# Groundwater Application Review Summary Form

Application # G- 19389

GW Reviewer Stacey Garrison Date Review Completed: 5/7/2024

**A. GENERAL INFORMATION:** Applicant's Name: Sokol Blosser Winery County: Yamhill

Water-Level Measurements in Nearby Wells (with Reference Levels)

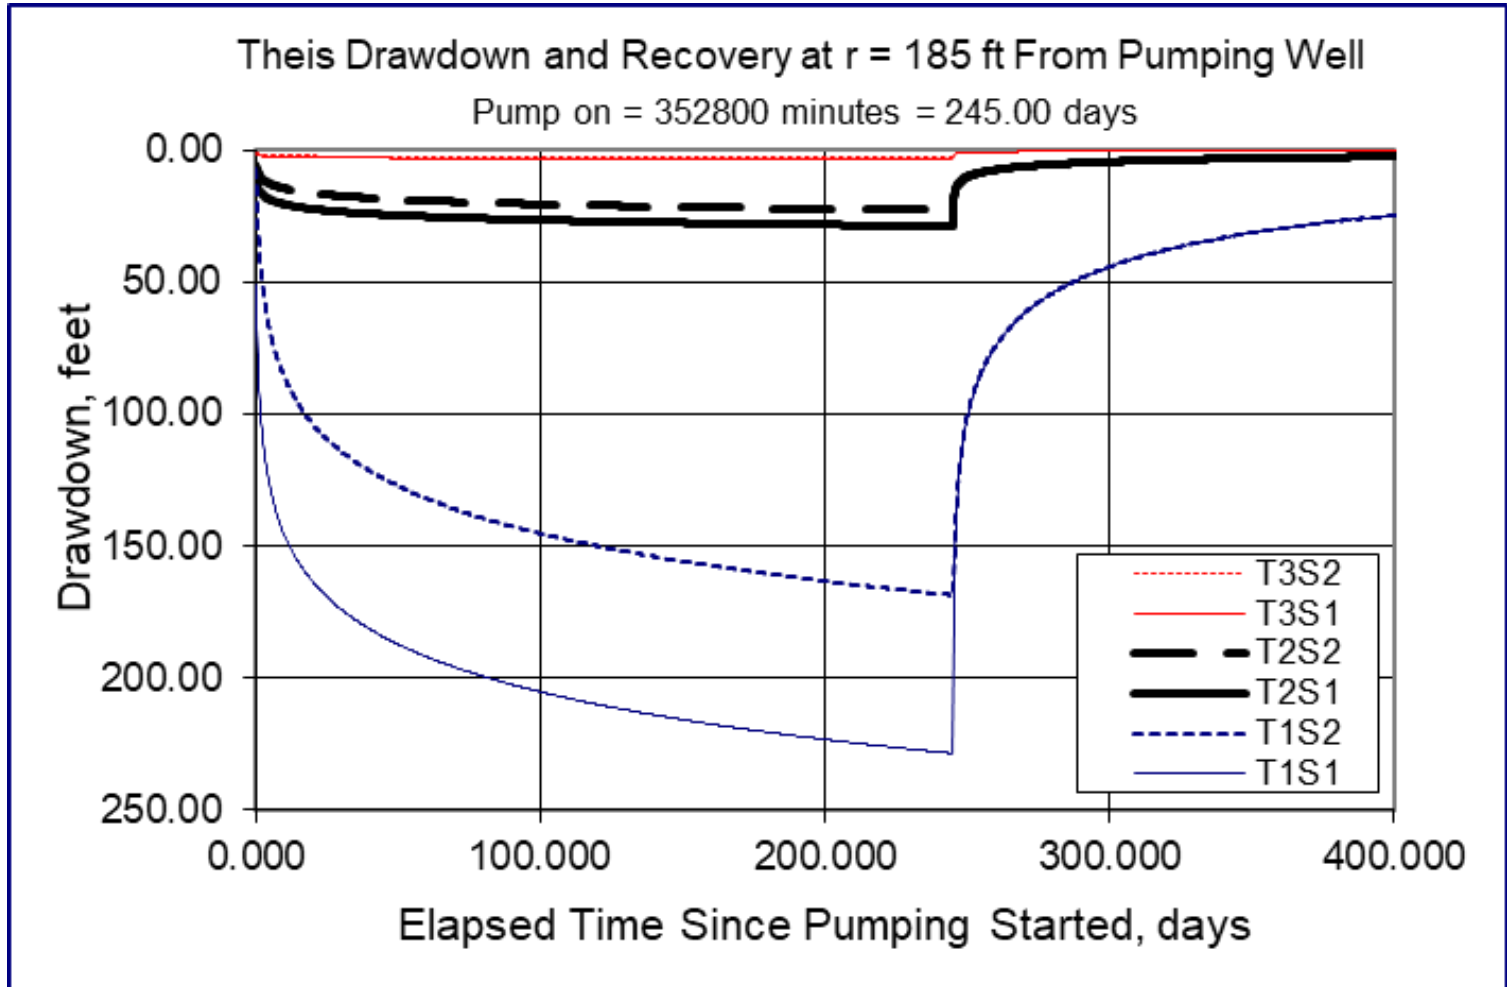
Water levels in nearby observation wells are steady (see Water Level Measurements in Nearby Wells). Within one mile, there were 22 CRBG observation wells in the Department's database. However, due to the compartmentalization anticipated from faulting, only three of the wells were identified as likely to demonstrate water level records applicable to the proposed POAs: YAMH 51607, YAMH 2807, YAMH 51038. Water levels in these three wells are steady. There are 25 POAs for 27 groundwater rights within 1 mile of the proposed POA, but the relatively stable water levels in the vicinity of the proposed POAs indicate the resource is not over appropriated.

**Theis Interference Analysis**  
**POA 4-YAMH 50136**

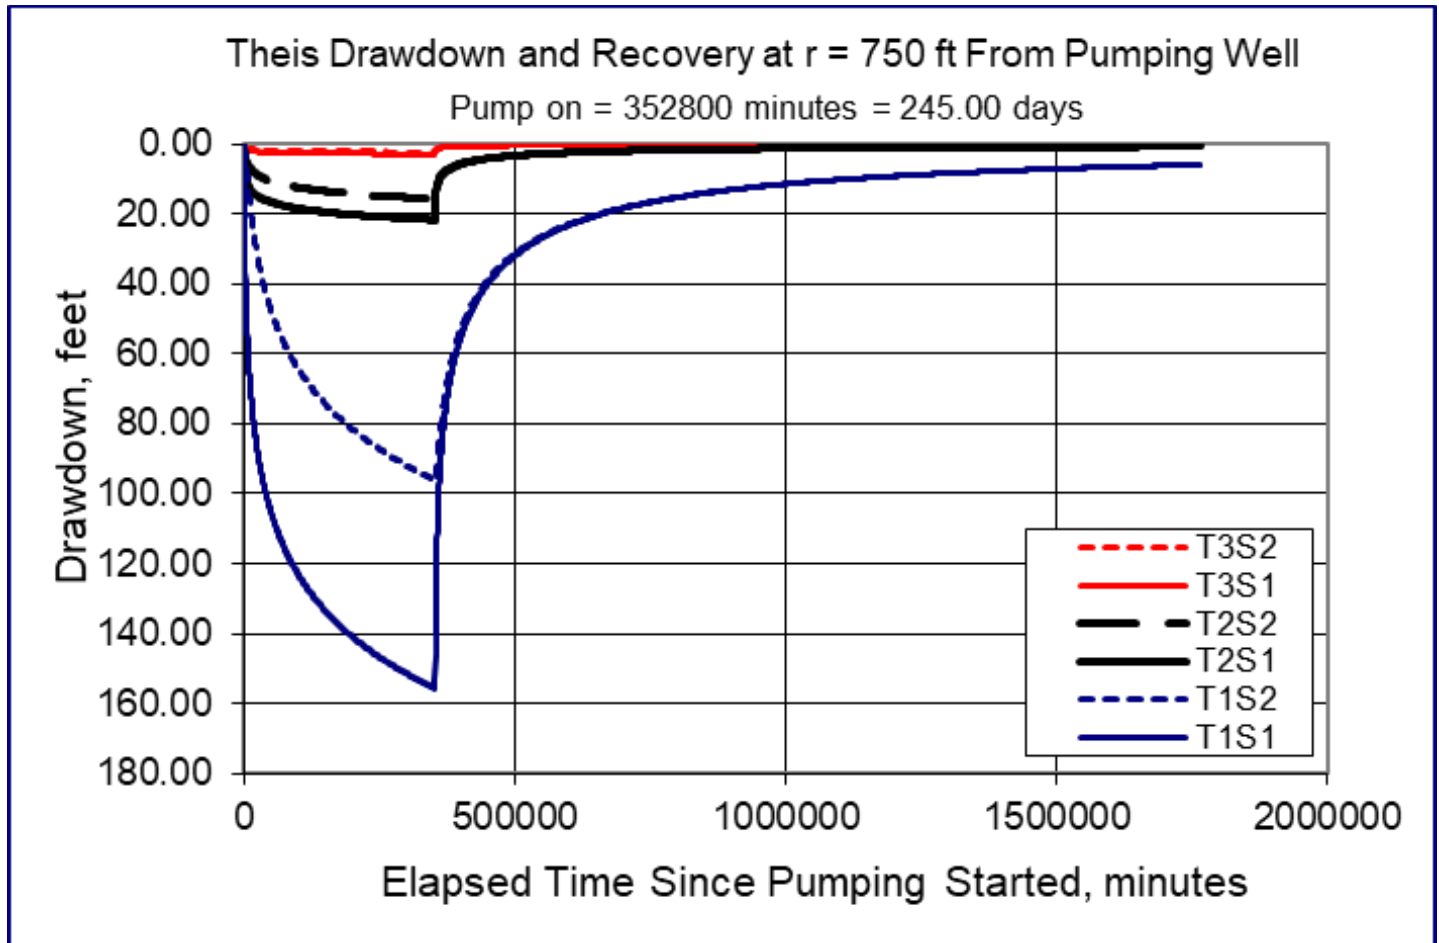
Radial distance from pumping well ( $r$ )=185 ft [estimated radial distance from POA 4 to nearest user, YAMH 50136]

**Pumping Rate ( $Q$ )= 0.151662 cfs (~68 gpm)\***

Aquifer Transmissivity ( $T_1$ )= 299 gpd/ft (40 ft<sup>2</sup>/day), ( $T_2$ )=2,992 gpd/ft (400 ft<sup>2</sup>/day), ( $T_3$ )= 29,920 gpd/ft (4,000 ft<sup>2</sup>/day) [McFarland and Morgan 1996, Conlon et al., 2005, OWRD Pump Test and Well Log Database]

Storativity ( $s_1$ ) = 0.0001, ( $s_2$ ) = 0.001 [McFarland and Morgan 1996, Conlon et al., 2005 values for Columbia River Basalt Group]

Total pumping time=245 days

\* The full pumping rate could not be utilized continuously for the entire 245-day period of use without exceeding the 73.7 ac-ft maximum allowed duty. For the maximum allowed duty of 73.7 ac-ft, continuous pumping would occur for 246 days at a rate of 0.151662 cfs (~68 gpm). However, scenarios where drawdown exceeds the total well depth (200 ft) are not feasible because there would be no water left in the well to pump.
